JONES & BEACH ENGINEERS INC.

April 10, 2022

RE: Response Letter
19 Old Gonic Road, Rochester, NH
Tax Map 131, Lot 1
JBE Project No. 21090

DRAWING No.
OFF3
 SHEET 36 OF 45
 JBE PROJECT NO. 21090

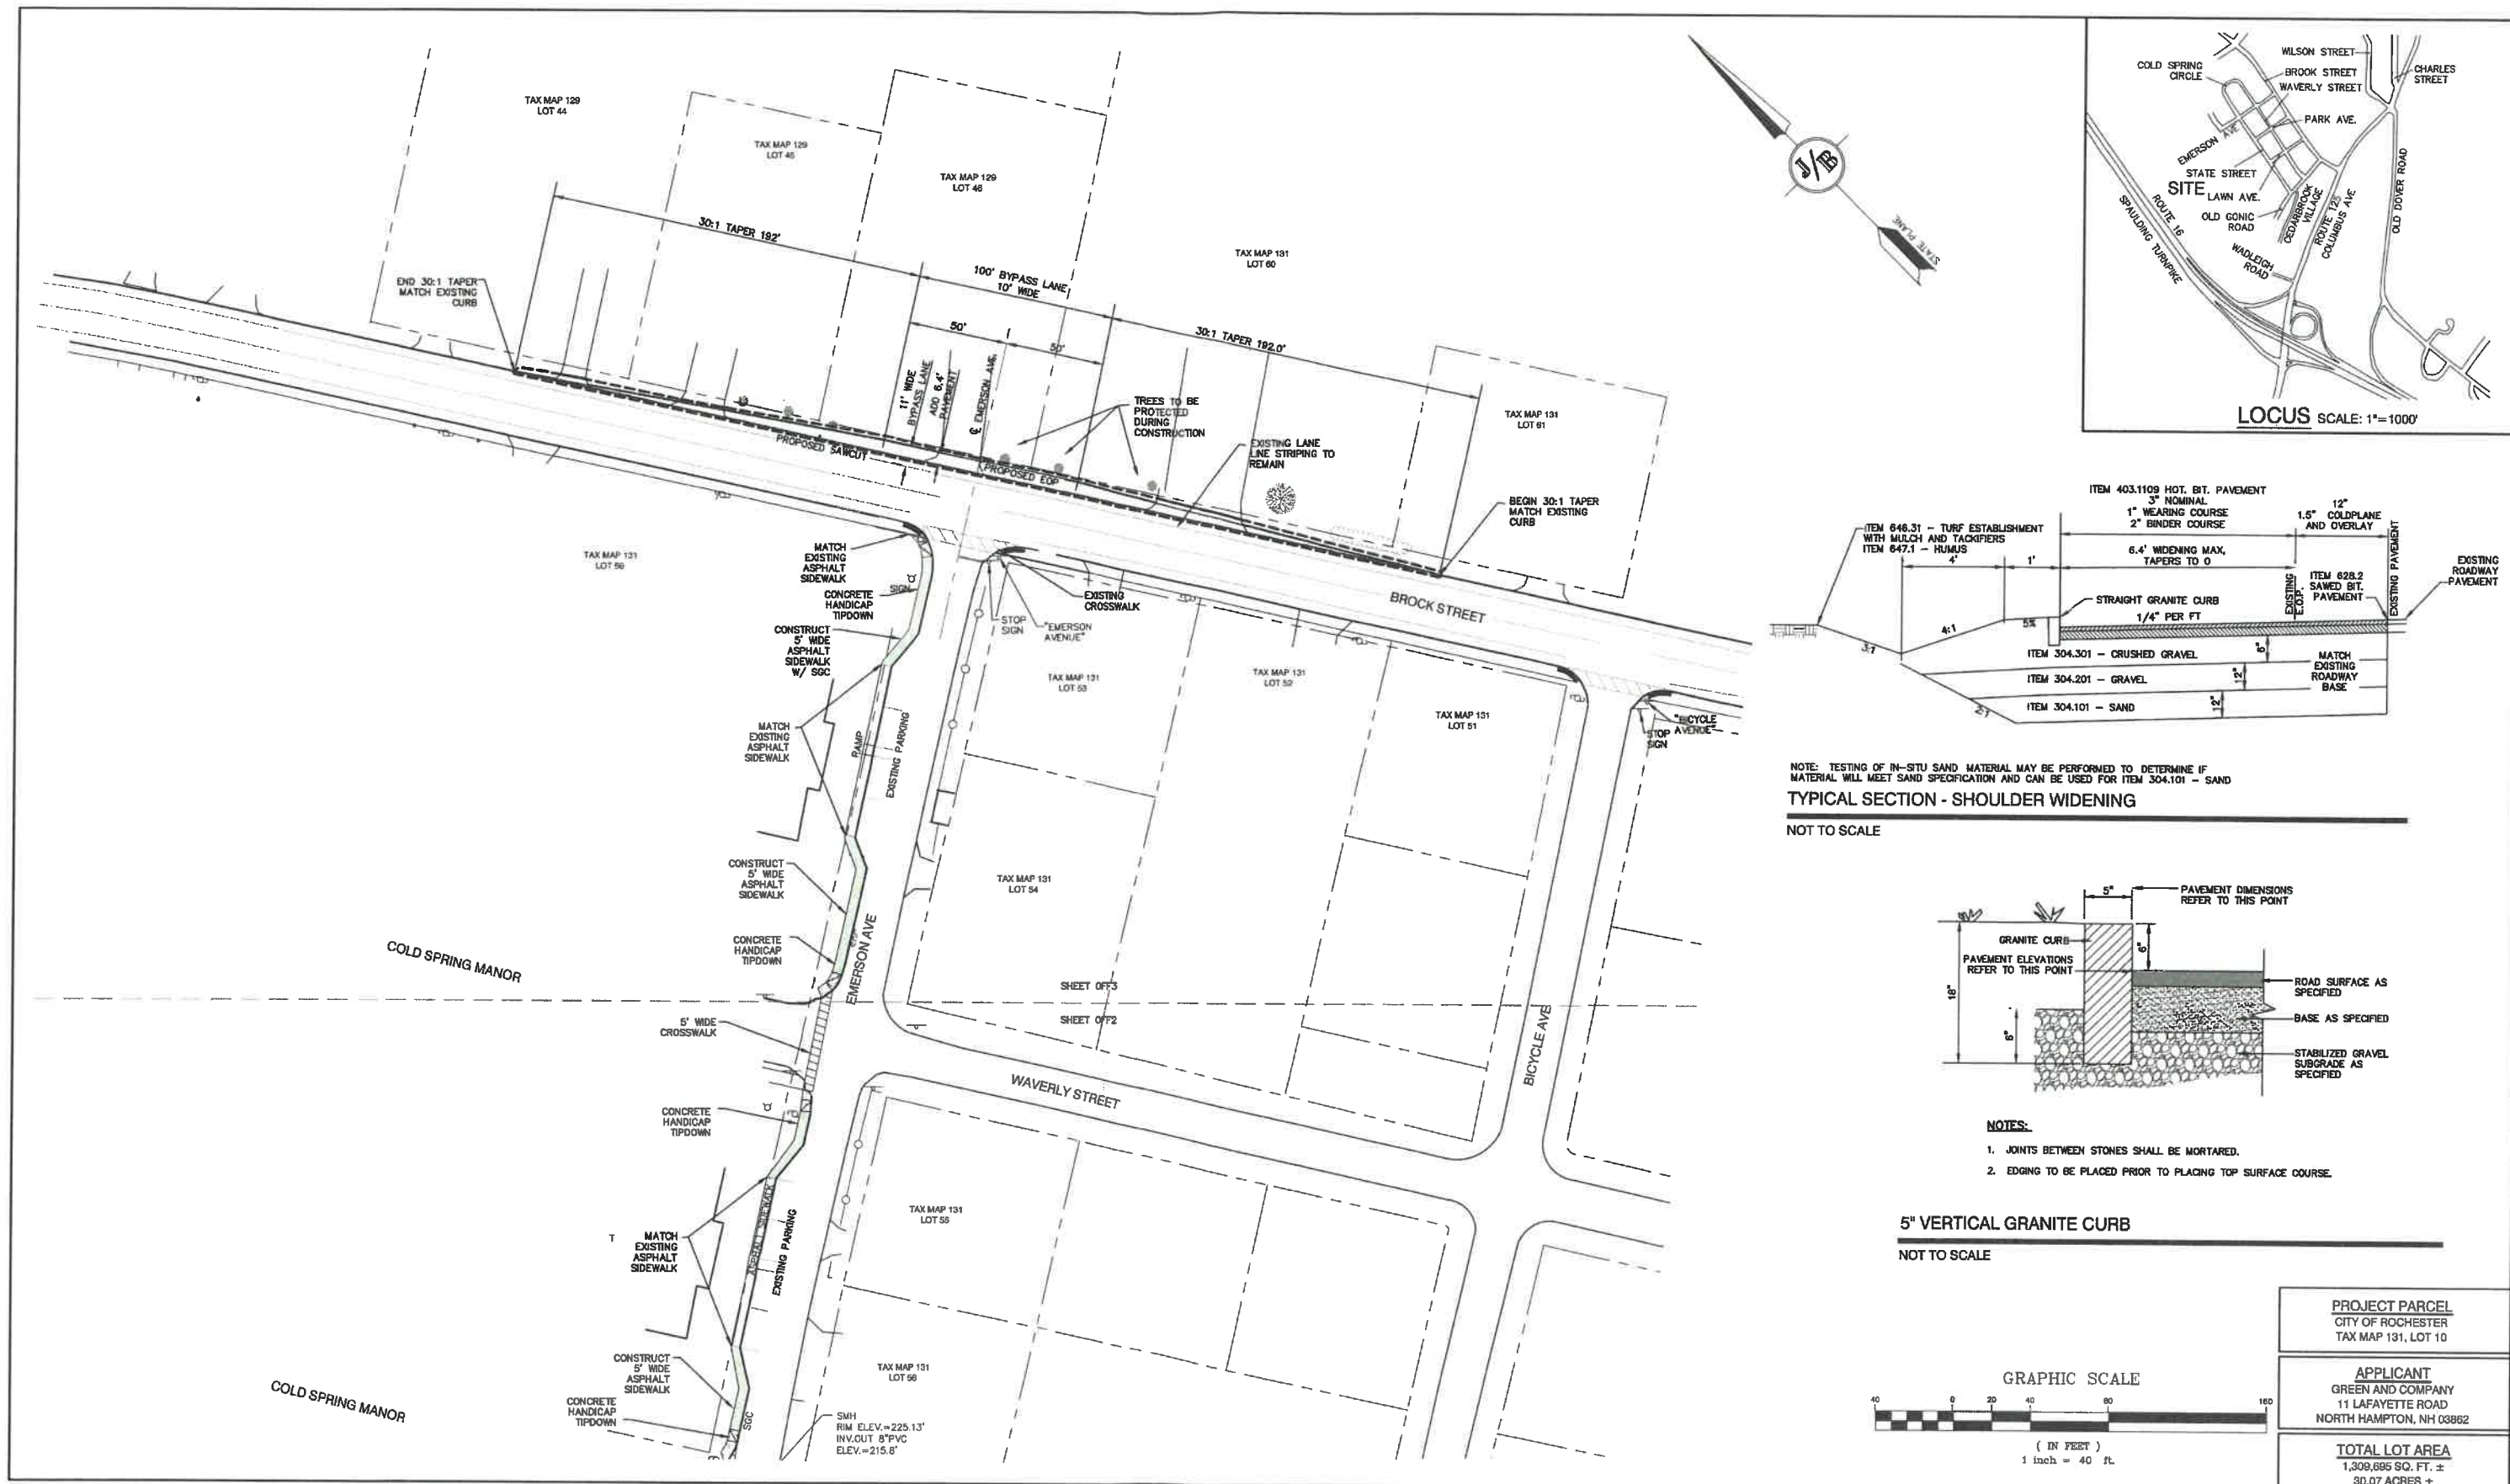
9. Sheet OFF 3- We agree that rather than a full auxiliary left turn lane a widened bypass shoulder would be appropriate at the intersection of Brock Street and Emerson Street. It is recommended to increase the shoulder width to 11' to provide an additional 1' offset from curb.

10. Sheet OFF3 – It is recommended to revise the Shoulder Widening Typical Section detail to have the full depth pavement structure extend to the existing edge of travel way and both the crushed gravel and gravel extend to the existing edge of pavement.

11. Sheet OFF3 – Overall further detail is required of the design of the shoulder widening. This would include items such as any modifications to pavement markings, how the proposed widening will interface with the existing residential driveways and detail to show any required modifications to the existing closed drainage system. Full grading design with cut/fill limits will need to be understood to evaluate any impacts to adjacent properties.

12. Sheet OFF3 – Applicant should coordinate with Rochester DPW on the desired pavement structure for the proposed shoulder widening.

DRAWING No. **OFF4**
SHEET 37 OF 45
JBE PROJECT NO. 21090

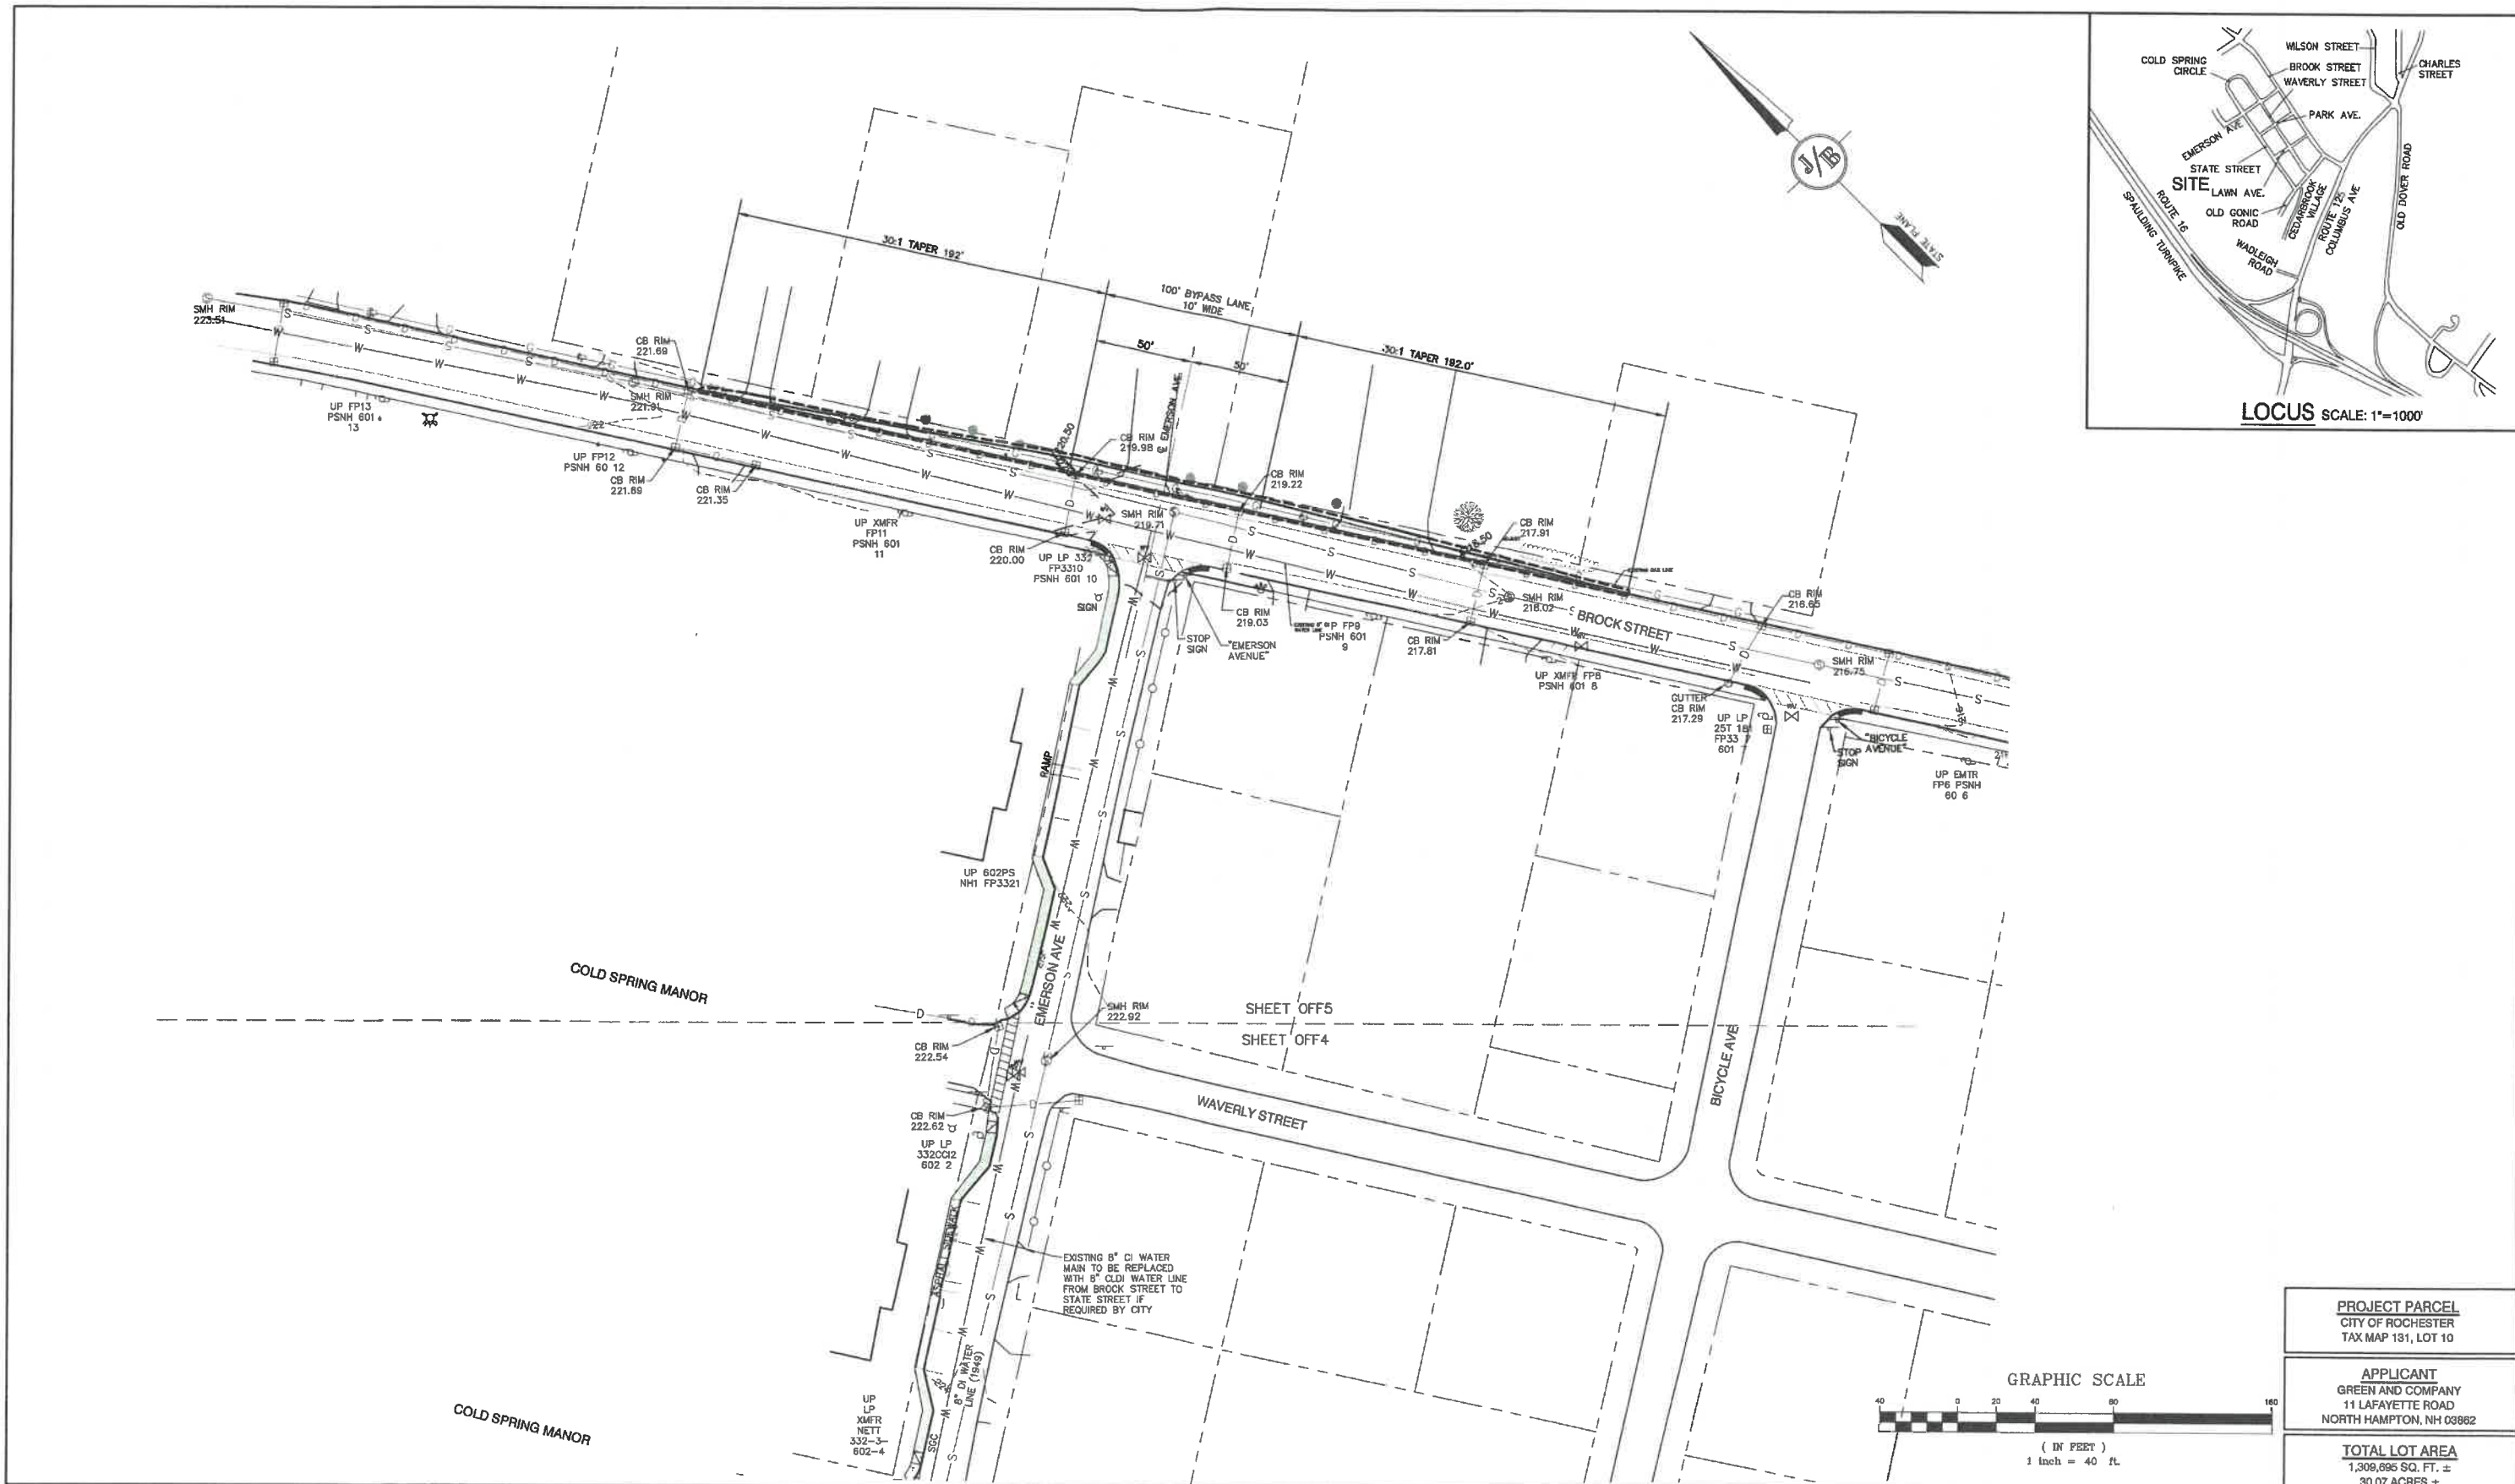
8. Sheet OFF2/3/4- The project proposes to construct a new sidewalk along the westerly side of Emerson Avenue connecting the development with existing sidewalk on Brock Street. Further detail should be provided for the proposed "handicap tipdown(s)" to ensure compliance with ADA standards and the NHDOT Sidewalk Details. Special attention should be made to how the proposed sidewalk will interface with the existing sidewalk/curb ramp at the intersection of Emerson Avenue and Brock Street.

RESPONSE: A handicap ramp detail showing concrete ramps is on Sheet D1 of the Plan Set. We plan to utilize the existing ramp at the intersection of Emerson Avenue and Brock Street. The proposed sidewalk will ramp down to the existing truncated dome area.
